Fixed TLine Tool Differential spacing Issue

Yongsheng.guo@ansys.com

2021-05-10

/ Before ANSYS_Electronics_Tline_toolkit_v2.1

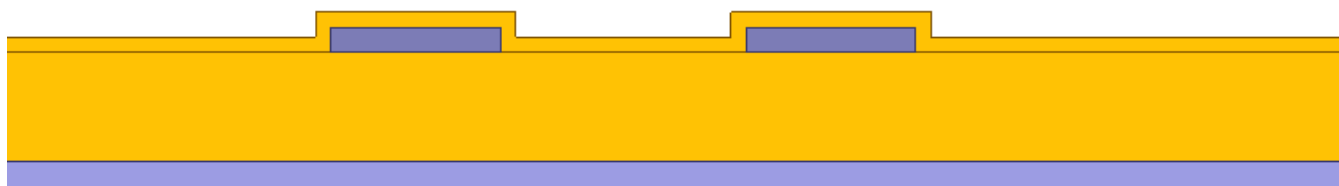
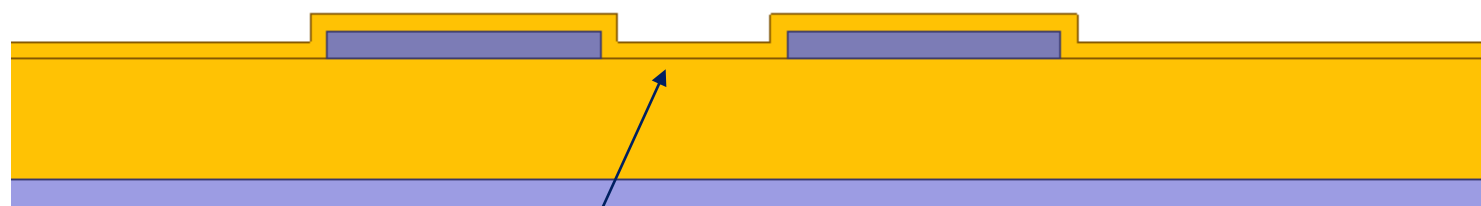
$$W/S = 5.5/8$$

Change W to 8

$$W/S = 8/8$$

$S < 8$, which is an error

/ New ANSYS_Electronics_Tline_toolkit_v2.2

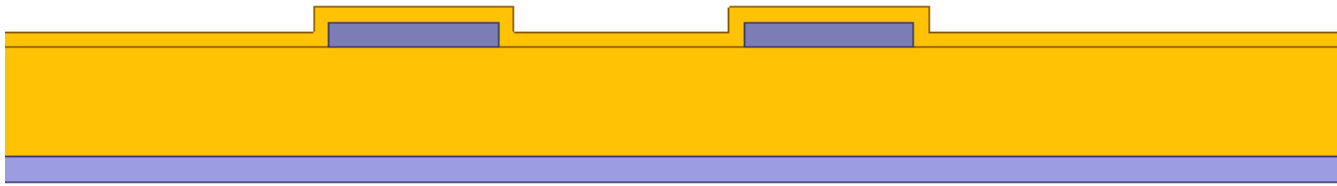
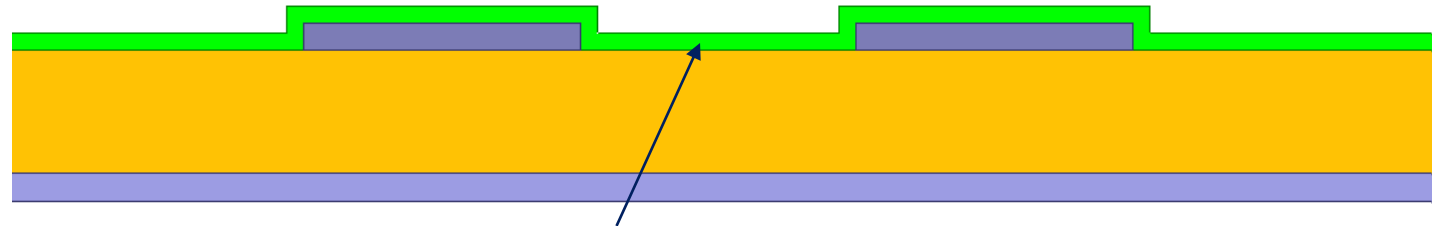
$W/S = 5.5/8$

Change W to 8

$W/S = 8/8$

$S=8$, Issue is fixed
